ADDENDUM NO. 1

PROJECT NAME: Nebraska Union First Floor Selective Refurbishment
UNL PROJECT NUMBER: C026P336
BID INVITATION NUMBER: 2209-13-7200

CONSULTANT: Holland Basham Architects
ADDRESS: 119 S. 49th Ave, Omaha, NE

DATE OF ISSUANCE: 20 August 2013
DATE OF BID OPENING: 27 August 2013

MECHANICAL DEMOLITION PLAN - NORTH

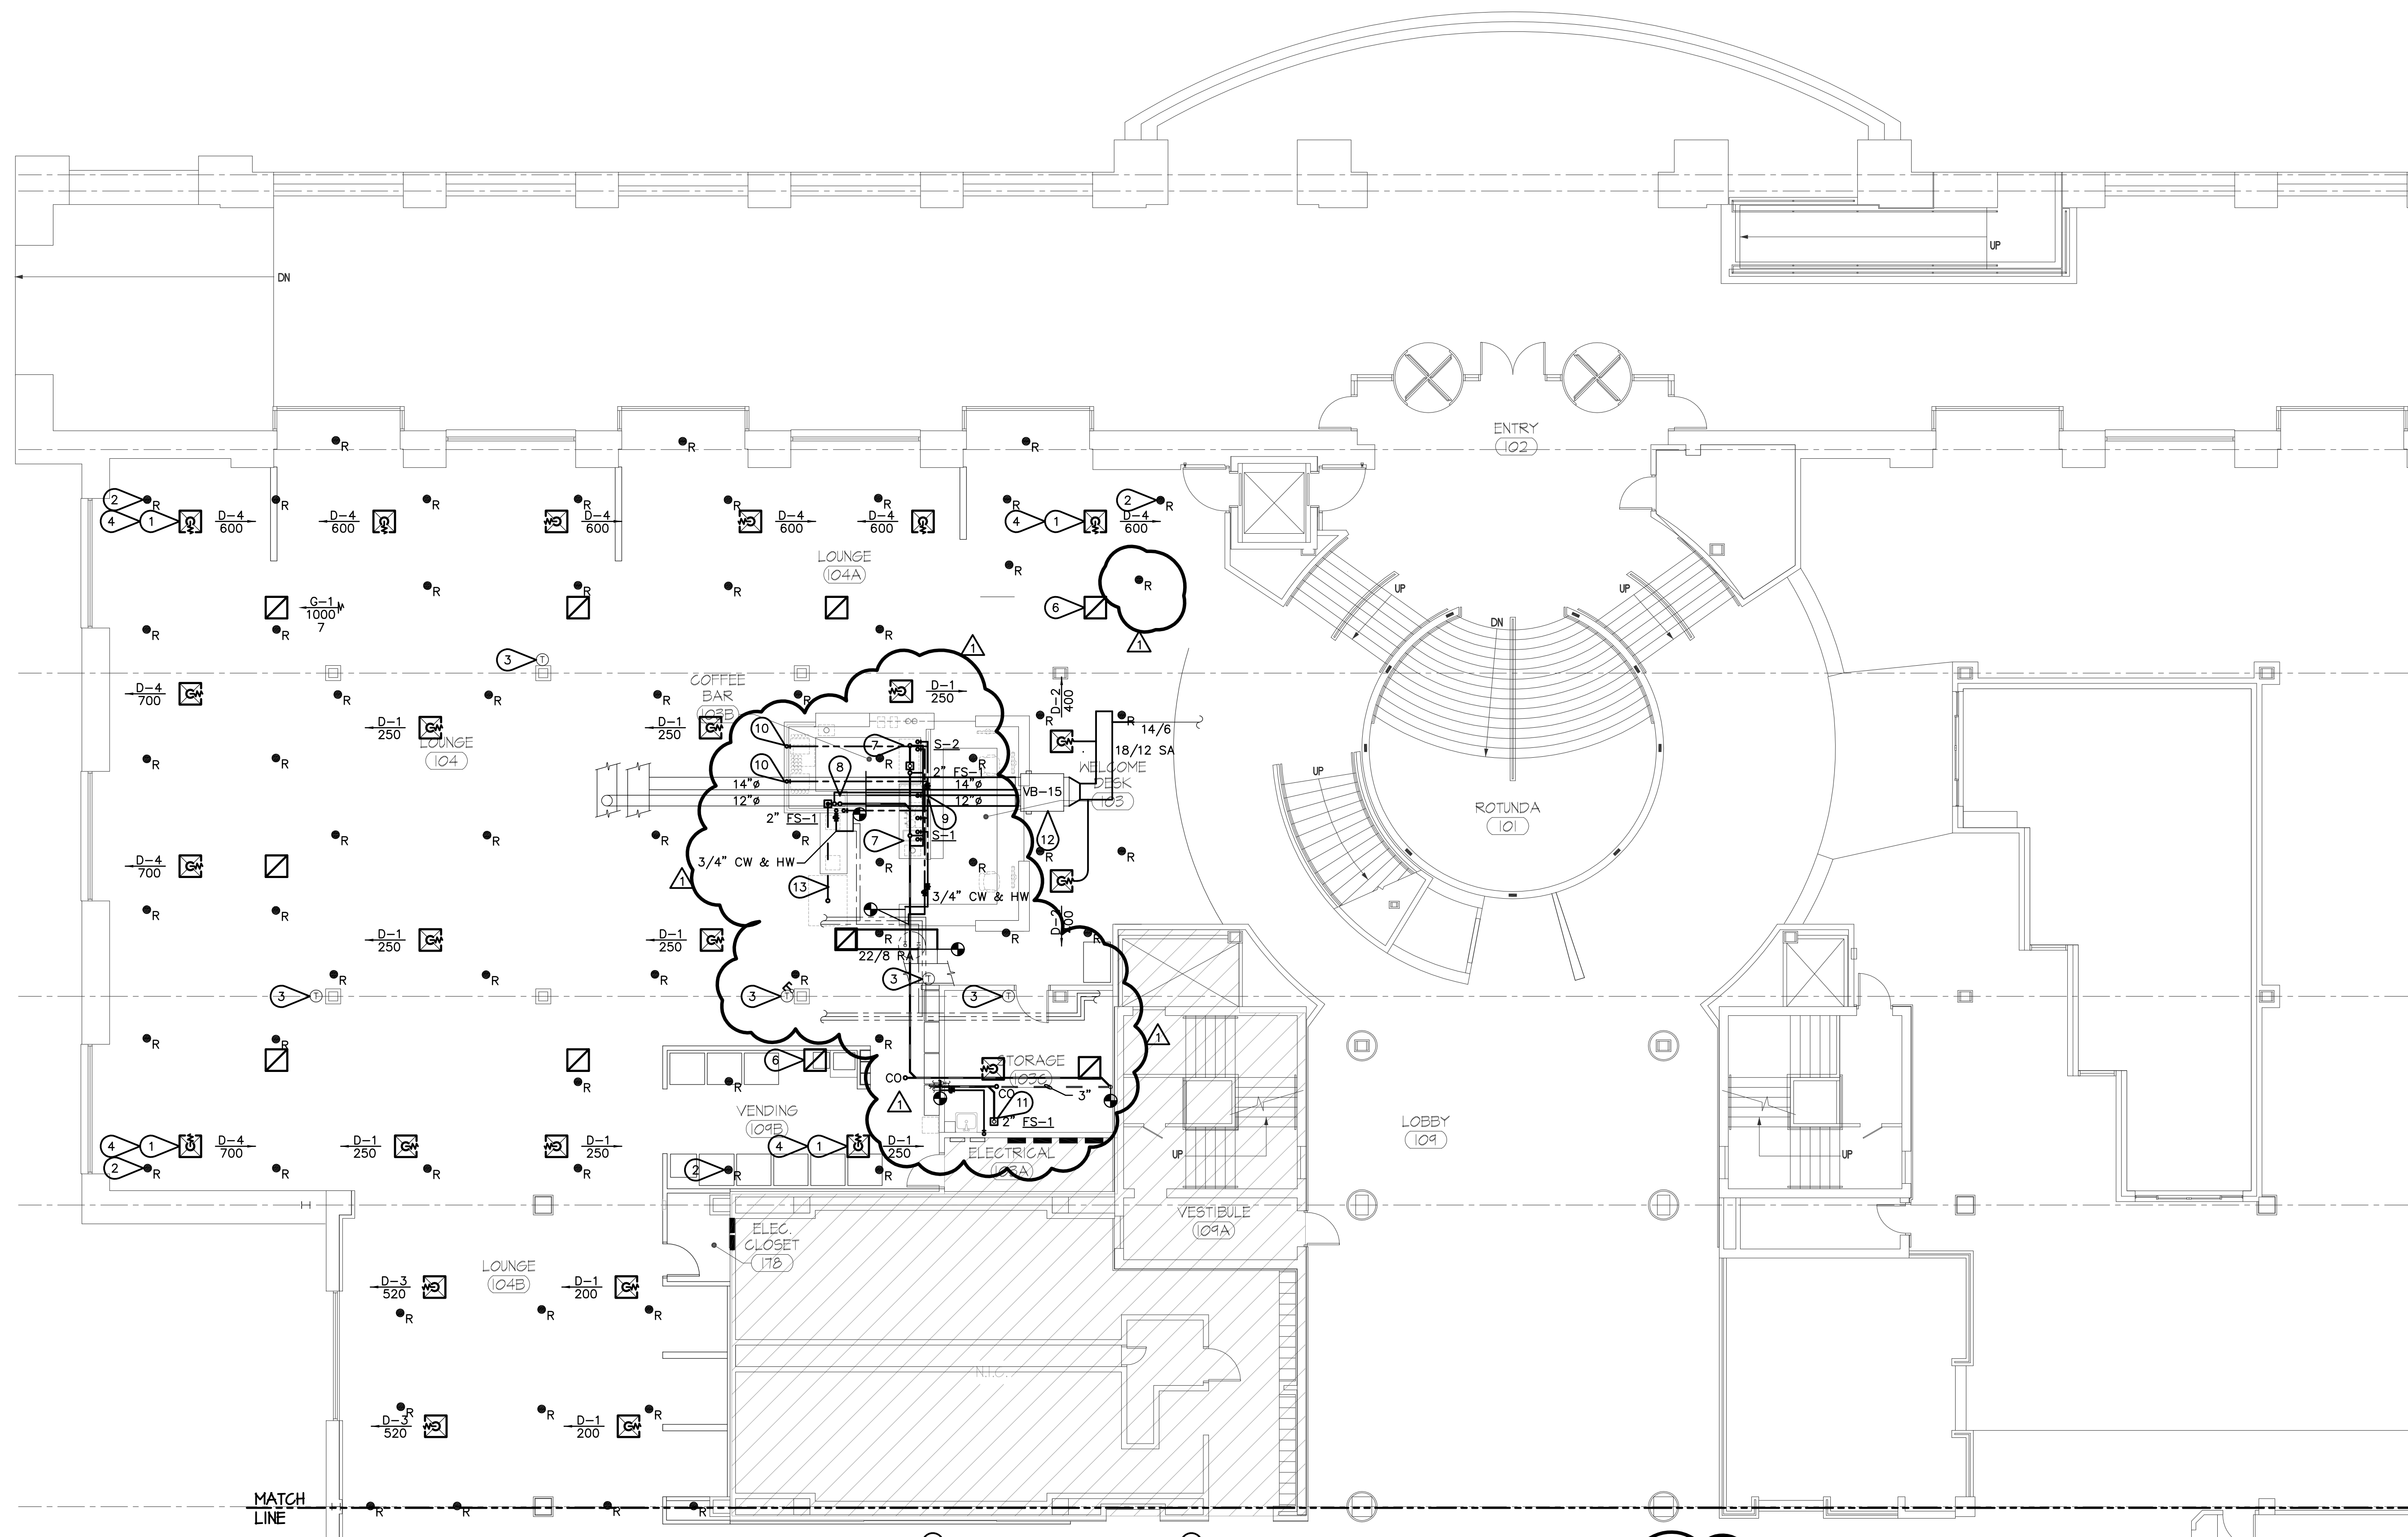
- a. Mechanical keynotes: Revise key note 11 and add key note 12 and 13.
- b. Plumbing revised to show locations of existing cw, hw and sanitary waste serving the coffee bar. All piping shown is at the ceiling of the lower level.

MECHANICAL PLAN - NORTH

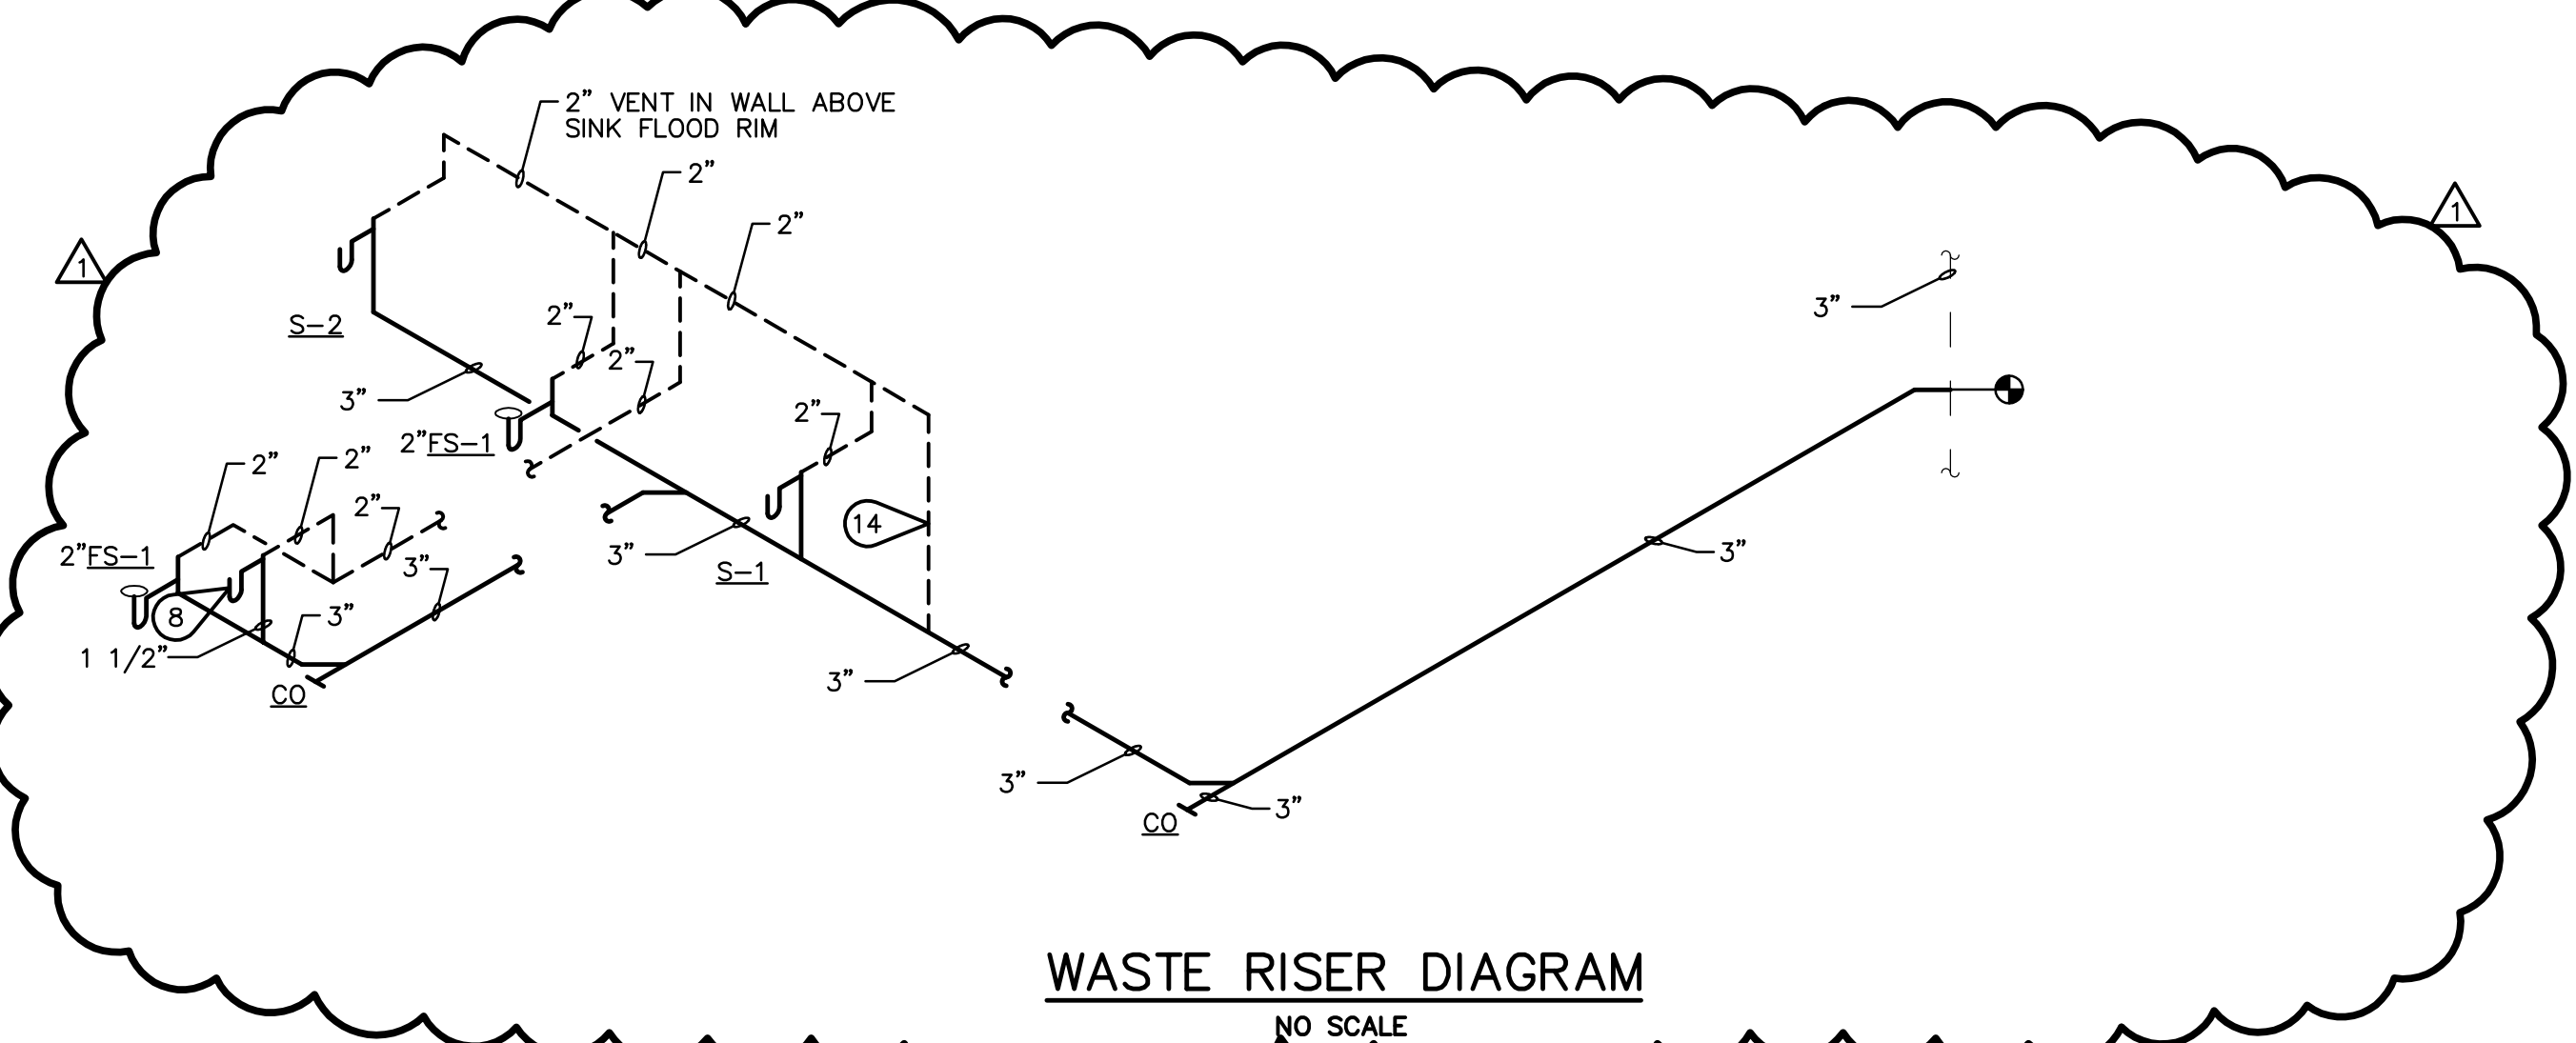
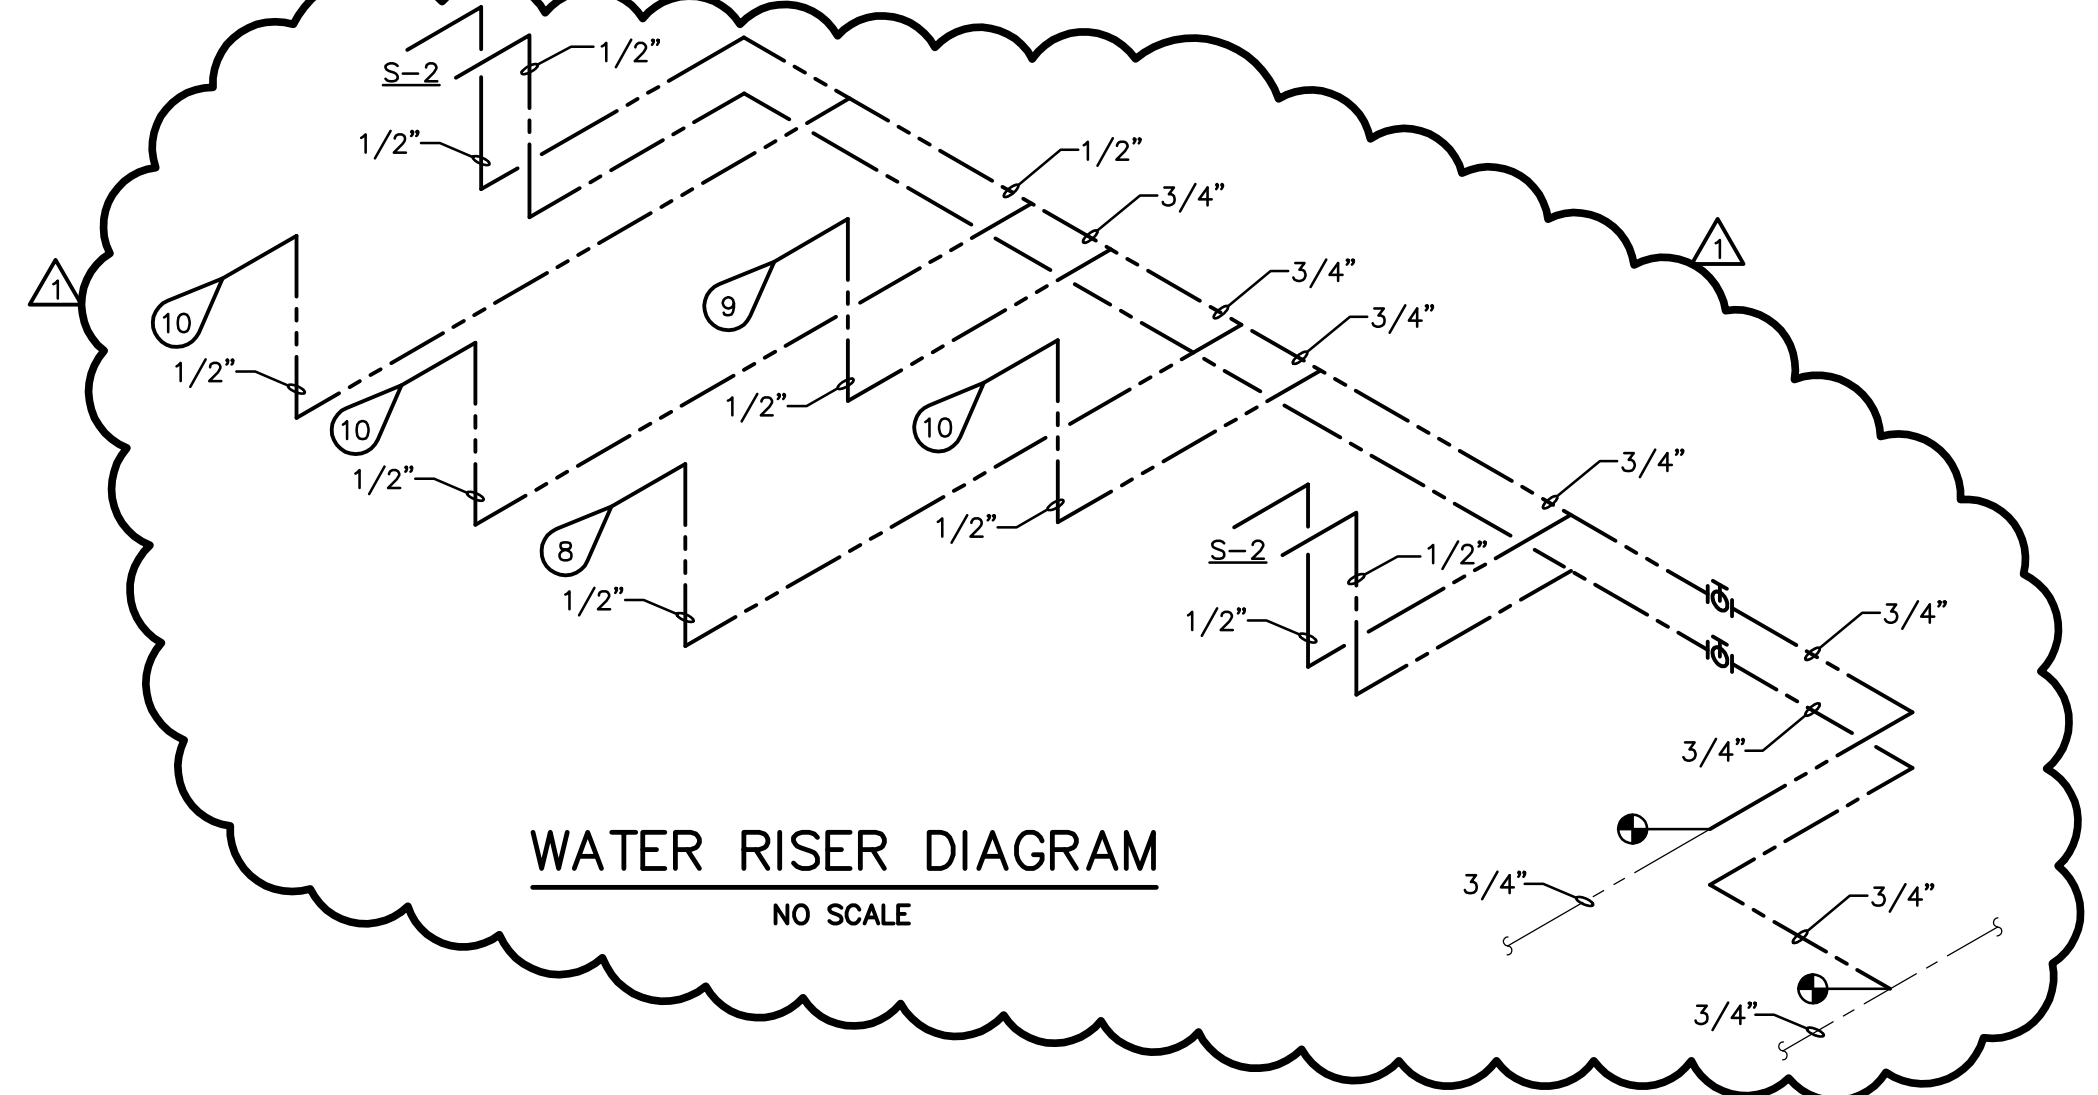
- a. Mechanical keynotes: Revise key note 8, 9 and 10 and add key note 14.
- b. General notes: Add general note d.

- c. Plumbing revised to show new cw, hw and sanitary waste serving the coffee bar. All piping shown is at the ceiling of the lower level.
- d. Fire protection system at and near ceiling of coffee bar and welcome desk is to be revised for new ceiling in this area.
- e. Add waste riser diagram.
- f. Add water riser diagram.
